# Access Compliance Report

## Public Rights-of-Way

### (Curb Ramps)

Intersection ID: 28071	Main Street: PINE_VALLEY_CLUB_DR	Cross Street: PROVIDENCE_COUNTRY_CLUB_DR	Location: NE
ADA ID: 0A67625F6894	Ramp Type: Perp	Initial Pass/Fail: Fail	Overall Compliance: No
Severity Score: 1.25			
Codes/Mitigation Info/Possible Solution		Field Measurements/Component Compliance

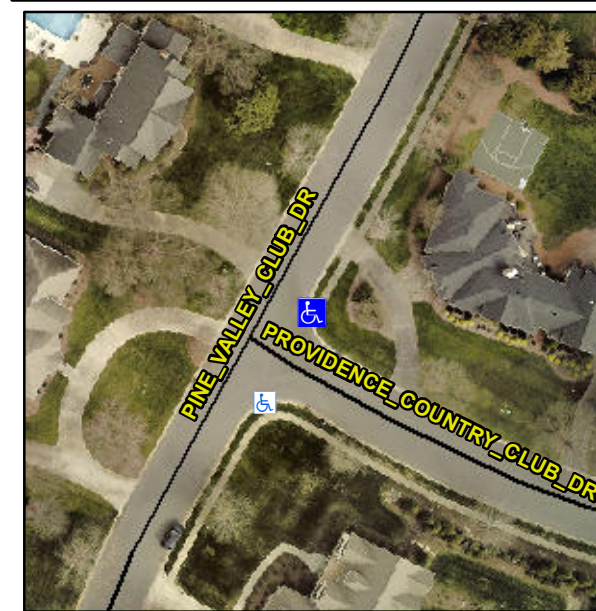
**Not Found, R304.5.3**

Compliance	Description	Data	Compliance	Description	Data
N/A	Ramp Length (in)	37.0	Yes	Ramp Slope (%)	5.4
Yes	Ramp Width (in)	48.0	No	Ramp XSlope (%)	2.4
N/A	Flare Type LT	N/A	N/A	Flare Type RT	N/A
N/A	Flare Slope LT (%)	N/A	N/A	Flare Slope RT (%)	N/A
N/A	Flare Traversable LT?	N/A	N/A	Flare Traversable RT?	N/A
N/A	Landing Length (in)	N/A	N/A	DWS Provided?	N/A
N/A	Landing Width (in)	N/A	N/A	DWS Contrast?	N/A
N/A	Landing Slope (%)	N/A	N/A	DWS Length (in)	N/A
N/A	Landing X Slope (%)	N/A	N/A	DWS Full Width?	N/A
N/A	Landing Curb? (Y/N)	N/A	N/A	DWS Offset (in)	N/A
N/A	Shared Landing?	N/A			
N/A	Gutter Ponding?	N/A	N/A	Gutter Slope (%)	N/A
N/A	Gutter Lip Ht (in)	N/A	N/A	Gutter X Slope (%)	N/A
N/A	Painted X Walk1?	No	N/A	Painted X Walk2?	N/A
	X Walk 1 Direction	To SW		X Walk 2 Direction	N/A
N/A	X Walk 1 Width (in)	N/A	N/A	X Walk 2 Width (in)	N/A
	X Walk 1 Slope (%)	4.2		X Walk 2 Slope (%)	N/A
	X Walk 1 X Slope (%)	4.2		X Walk 2 X Slope (%)	N/A

**Remove & Replace Entire Ramp.**
